## Place, Design and Public Spaces

### Response to Submissions Report

<b>DPIE Reference Number</b>	PP-2020-141 PP_2020_NORTH_004_00
<b>Sydney North Planning Panel Reference Number</b>	2019SNH042
<b>LGA</b>	North Sydney Council
<b>LEP to be Amended</b>	North Sydney Local Environmental Plan (LEP) 2013
<b>Planning Proposal</b>	The planning proposal seeks to: <ul style="list-style-type: none"><li>• Increase the maximum building height from 12 metres to RL133 metres (24 storeys).</li><li>• Introduce a maximum floor space ratio (FSR) of 6.1:1.</li><li>• Introduce a new Special Provisions clause and related map and identify the Precinct on the map as 'Area 1'.</li><li>• Introduce a new Additional Local Provisions clause which incentivises site amalgamation through additional building height and includes solar access protections to Doris Fitton Park.</li></ul>
<b>Address</b>	173-179 Walker Street and 11-17 Hampden Street, North Sydney
<b>Lot and DP</b>	SP 11082, SP 86752, SP 9808 and SP 64615 Lot 1 DP119732, Lot 1 DP591516, and Lot 2 DP591516

The purpose of this report is to provide a summary of the key matters raised within submissions during the public exhibition of the planning propo

Figure 10: View sharing diagram (Source: SJB).

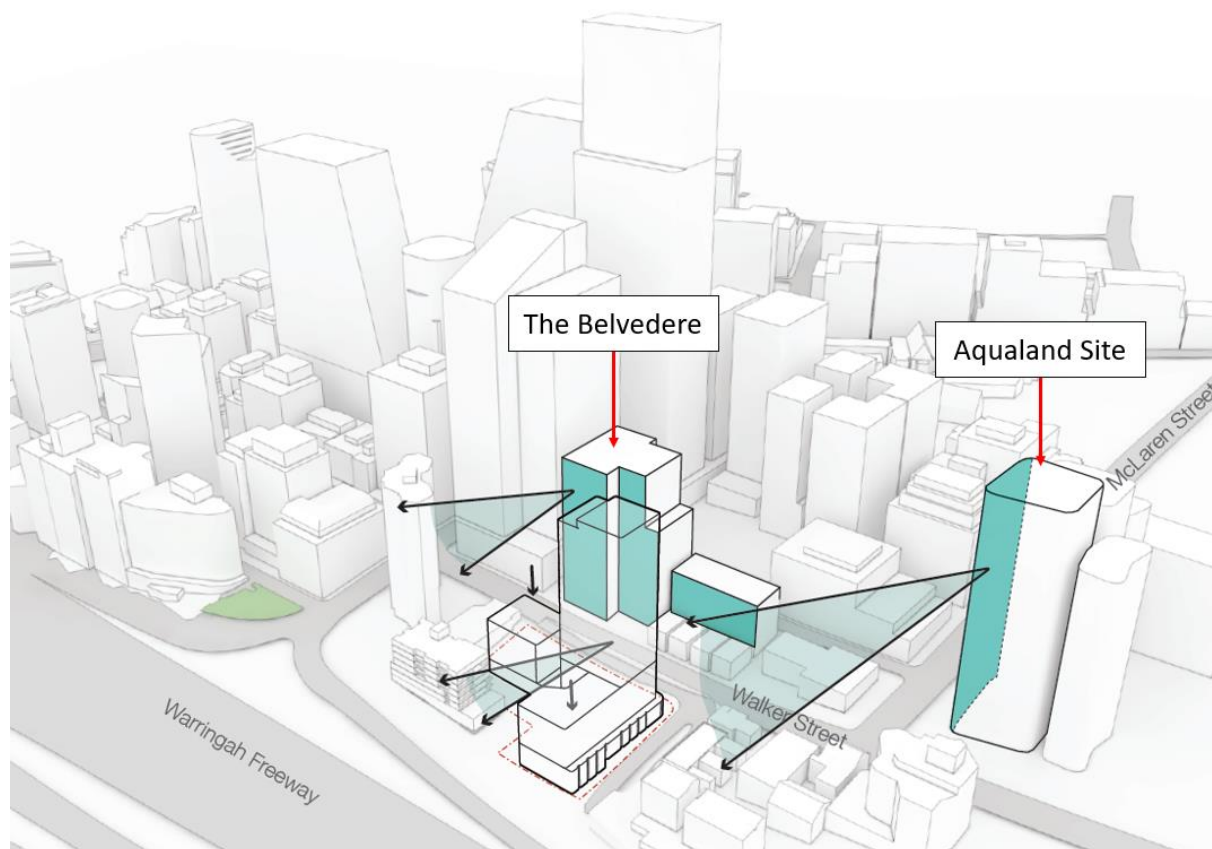
The proponent states that the Belvedere (west of site) submission has not properly reviewed the new revised proposal. In which, the building envelope shifts the tower form to the north with the specific objective of addressing previous feedback about view loss and overshadowing. By shifting the built form north this allows for view sharing and preserves the majority of views from the Belvedere tower (**Figure 10**).

The break within the building envelope has been designed to retain views from within Belvedere, across the site. This view corridor is evident in the building envelope plan (**Figure 11**). A full view corridor from west to east is provided in the 12m gap between built forms and above 8 storeys over the southern building. The Belvedere tower is 20 storeys.

Figure 11: Building envelope plan showing view corridors (Source: Urbis).

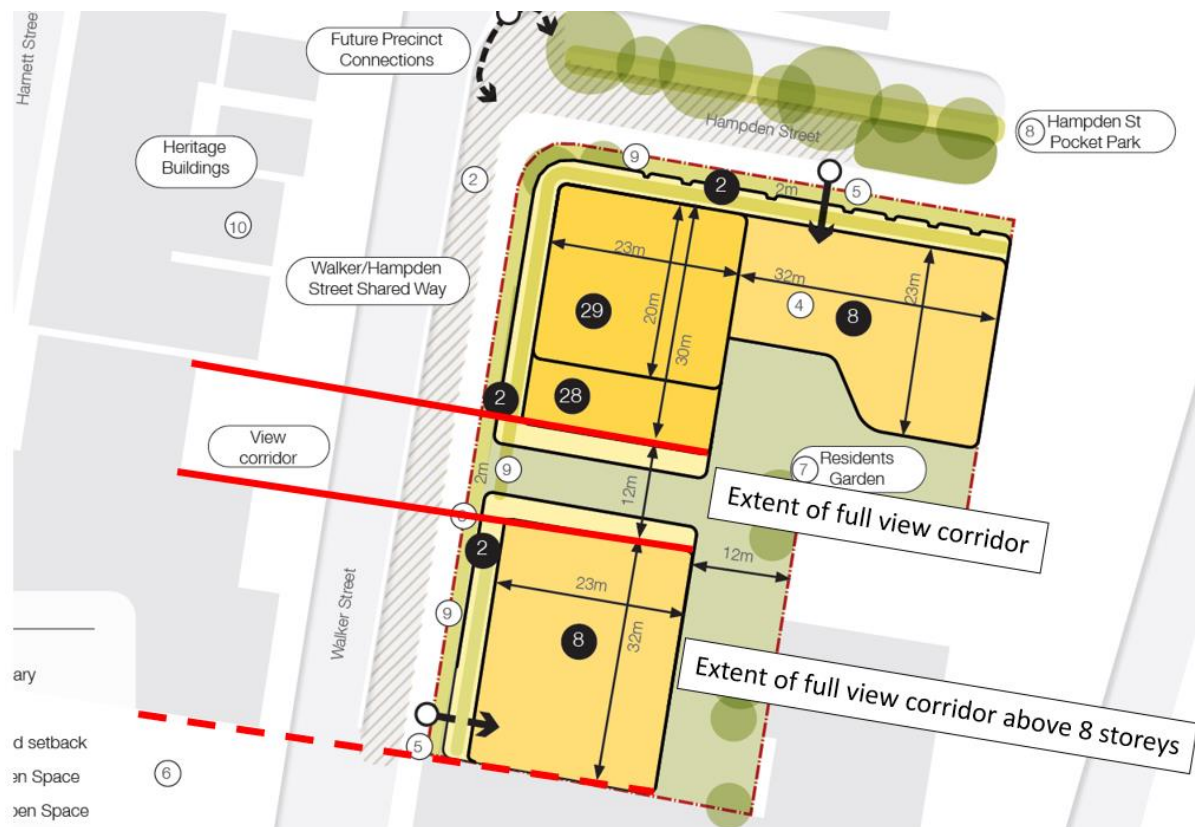
Residents and building managers to the west of the site (Walker, Miller Street, including the Aqualand and Belvedere buildings) raised concerns about view losses east to the harbour.

Submitters identified that the view impact analysis is inadequate and requires further refinement. The proponent's analysis is considered to be dismissive of loss of views from Miller Street, and only considers sharing of harbour views and not the extensive district views to the east. Submissions claim that the view impact assessment submitted with the original planning proposal does not appear to have been updated to respond to the revised scheme.

Aerial imagery and the location of the tower confirm that it is located to the north west of the Belvedere apartments and therefore, upper level views from these apartments would likely be retained.

The proposed building envelope promotes view sharing by consolidating the tower form to the northwestern corner, enabling a view corridor across the southern portion of the site. The proponent's Visual Assessment Report dated August 2020 reflects the intended building envelope that was refined to satisfy the recommendations of the Panel and the conditions of the Gateway determination.

Figure 12: Comparison of former and revised schemes (Source: SJB).

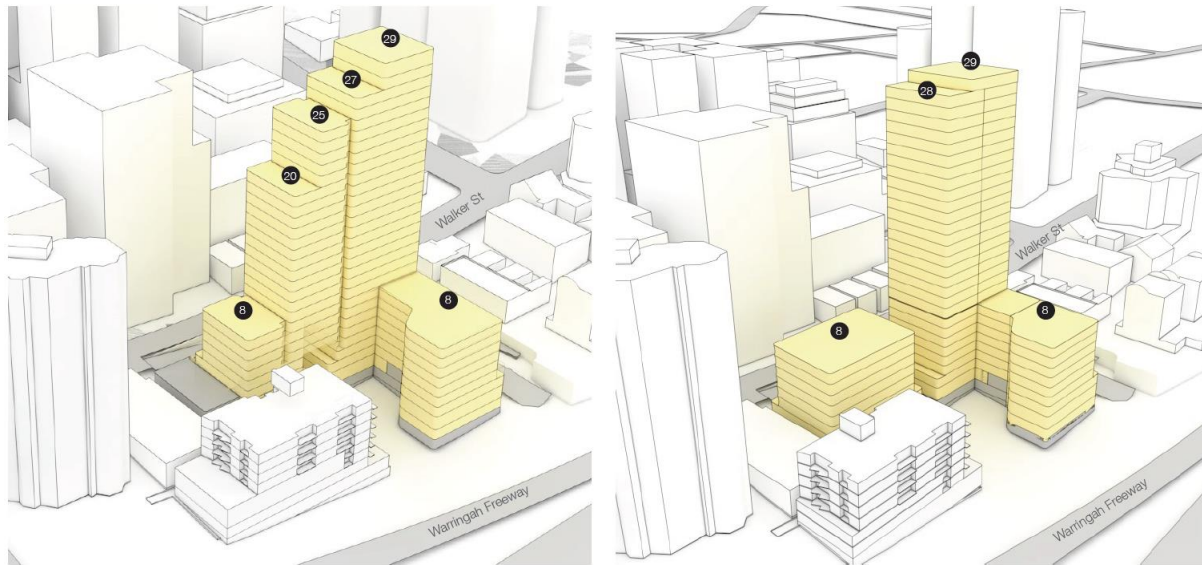
The Department considers that the majority of submissions raised concerns about missing out on the morning sun and views through the site from the West to the East, and rightly this has been the focus of refinements to the proposal.

The site is at the edge of a major CBD, where high rise commercial and residential towers are characteristic of surrounding development. On a site that is zoned high density residential it is expected that some views will be impacted, however the proposal has been modified to provide for increased view sharing and decrease bulk and scale. The evolution of the design scheme is shown in **Figure 12**.

The Panel has already indicated its support for development on the site for a tower up to 29 storeys (RL 148m) having regard to environmental factors such as overshadowing and view sharing.

Figure 13: Overshadowing impact of proposal to neighbouring properties between 9-9:15am during mid-winter (Source: SJB).

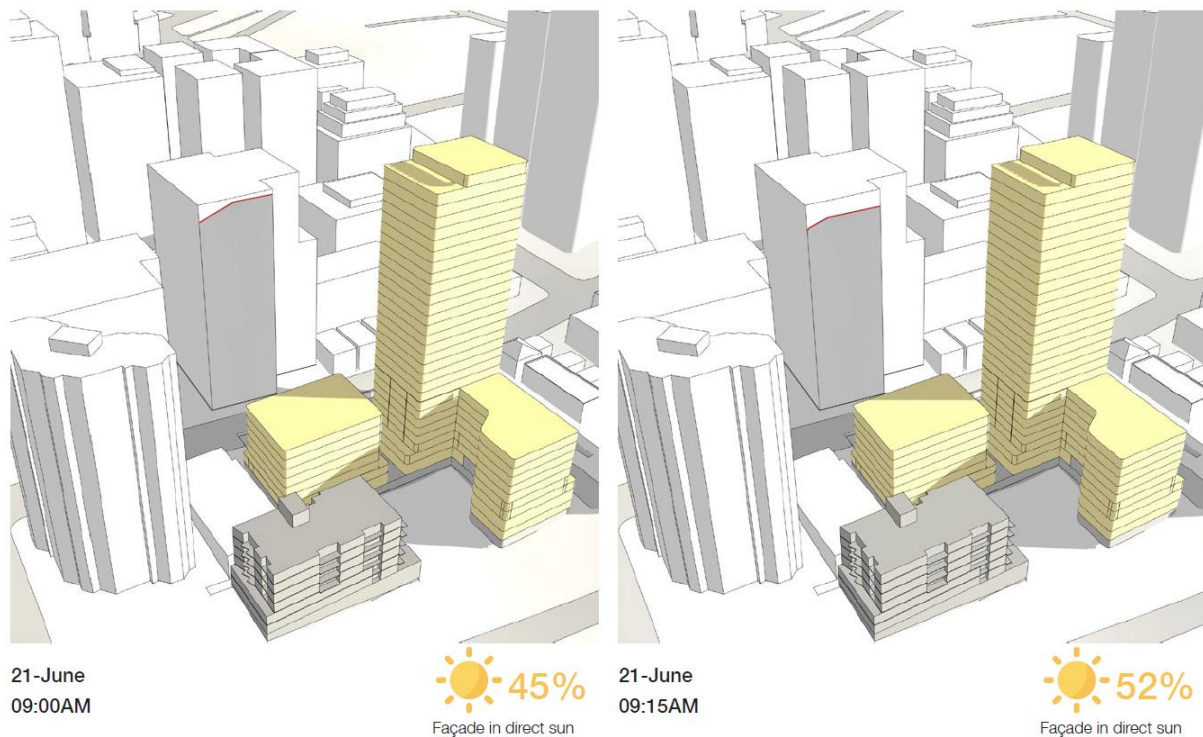
The proposal is supported by an urban design report by SJB which includes shadow diagrams showing impact on other buildings and sites nearby. These diagrams show there is no additional overshadowing impact to any existing or proposed open space on the 21<sup>st</sup> June (winter solstice).

The overshadowing impacts are considered to be minor and for a short duration (i.e. less than 1 hour), and overall, the proposal satisfies the SEPP 65 Apartment Design Guidelines (ADG) solar access objectives with respect to maintaining the amenity of neighbouring properties.

The Walker Street 'Heritage' residences are located to the north of the Belvedere tower (**Attachment C2**). At 9am, the building envelope does not result in any overshadowing to these properties. Solar access is therefore maintained for a minimum of 2 hours to 70% of apartments within 'The Heritage'.

Figure 16: Height transition from the North Sydney CBD to the subject site (Source: SJB).

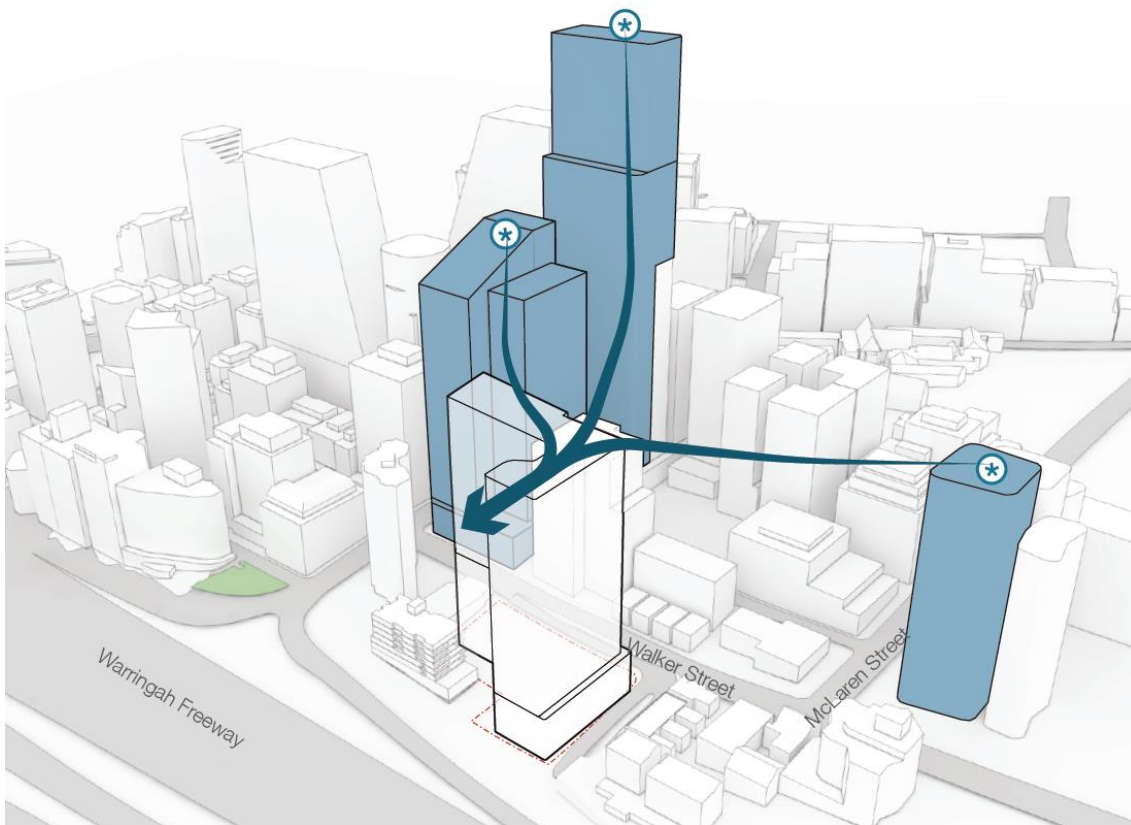
Submissions consider that the requested heights do not provide an appropriate transition of building heights from the existing CBD development to the subject R4 High Density Residential zoned land and the heritage area.

The proposal is not considered consistent with Civic Precinct Planning Study, which proposes a 20 storey height for the site. The proposal represents excessive bulk and scale. The building FSR of 6:1:1 is excessive in comparison to the existing controls.

The endorsed height of RL 148m for the East Walker Street Precinct provides a height transition down from the planned heights within the Ward Street Precinct to the west.

The proposed building envelope provides a height transition down from the planned heights of RL 168m – RL 225m within the North Sydney CBD Ward Street Precinct Masterplan to RL 148m on the site, providing for a height transition which falls away to the freeway and the low density residential areas in the east (**Figure 16**).
